PLANNING AND ZONING COMMISSION AGENDA

Thursday, January 22, 2026, at 6:00 PM
City Hall, 1838 Emerald Hill Lane
Westminster, Maryland 21157

Item B: Site Development Plan S-24-0031, William Winchester Elementary School Addition (Andrea Gerhard, DCPD)

Item C: Site Development Plan S-24-0032, Westminster Elementary School Addition (Andrea Gerhard, DCPD)

SITE PLAN

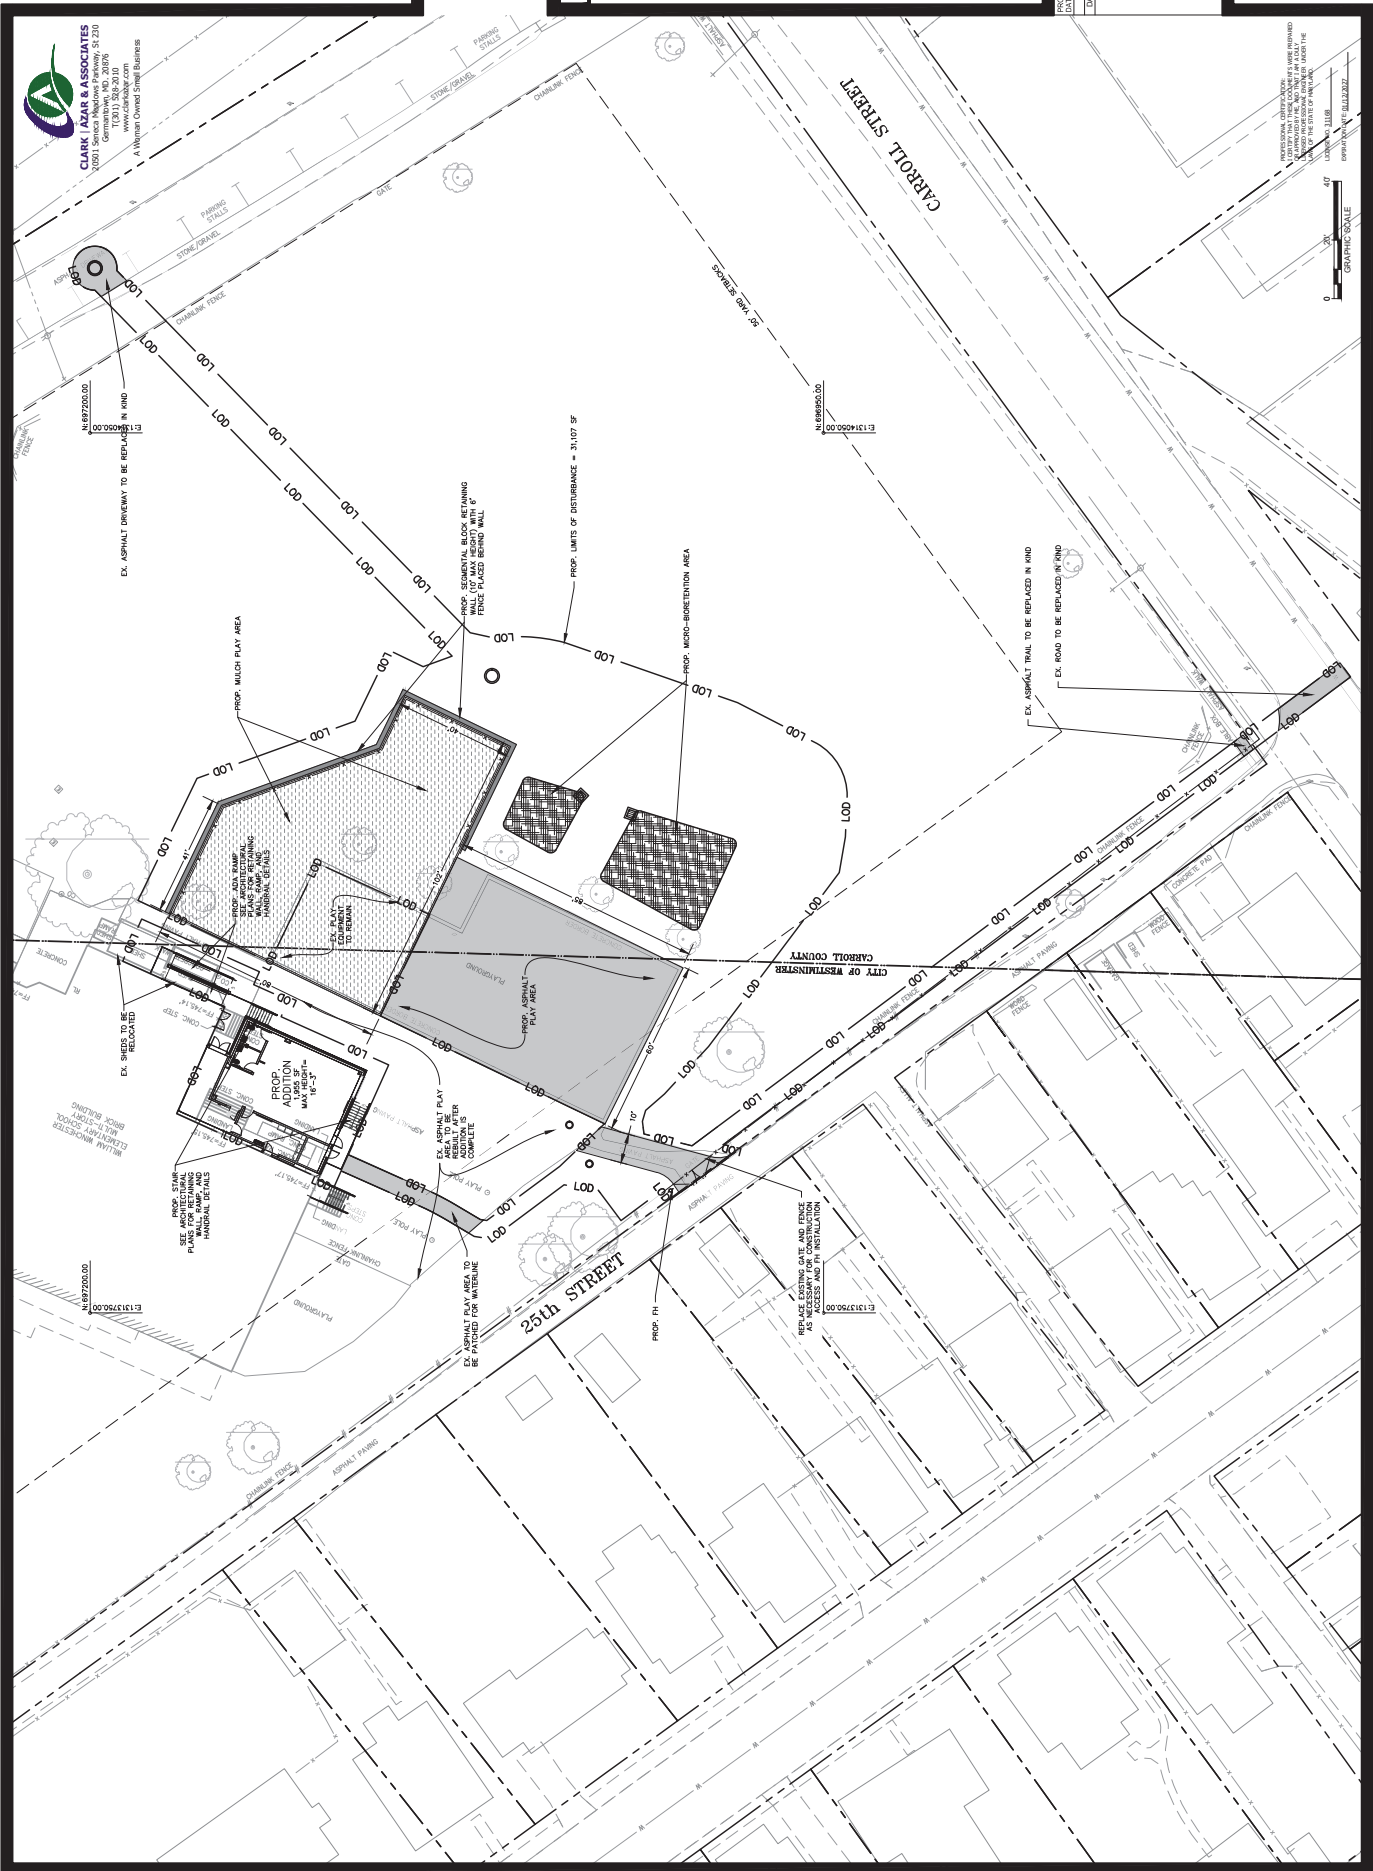
The Applicant submitted a Water and Sewer Allocation Application WSA-24-51 for a 1,948 square foot addition. This was based on preliminary drawings. There is no change in water allocation when the actual square footage of the addition, 1,955 square feet, are used. The multiplier for the water was based on the additional capacity for students created by this addition. It was calculated that 860 gpd would be needed to serve the 43 additional students. A note will need to be added to the front cover referencing the WSA information and the water allocated for the project.

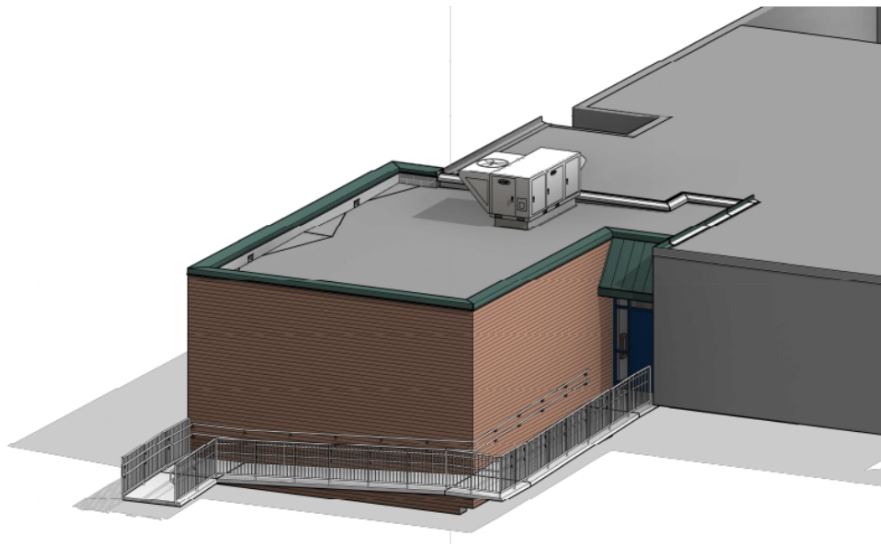
Pursuant to Zoning Ordinance Section 164-131.1., Compliance with Landscape Manual, S-24-0032 must comply with the adopted Landscape Manual, as amended. Department of Community Planning and Development (DCPD) staff reviewed S-24-0032 for compliance with the Landscape Manual and other applicable Zoning Ordinance landscape requirements.

No additional landscaping is required for these additions.

Elevations for the Pre-School Addition

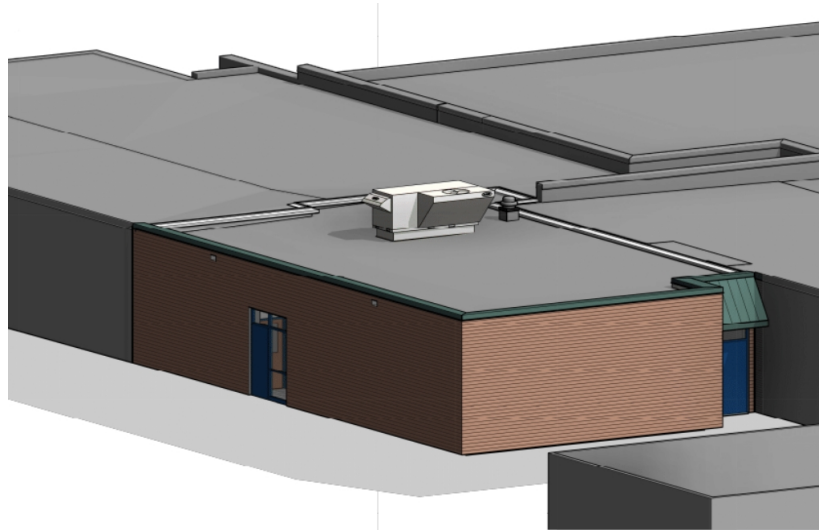
Pursuant to Zoning Ordinance Section 164-131.2., Compliance with Development Design Preferences Manual, S-24-0032 must comply with the adopted Development Design Preferences Manual, as amended, in coordination with other provisions and requirements of the Zoning Ordinance. The addition is compatible with the existing building on site.
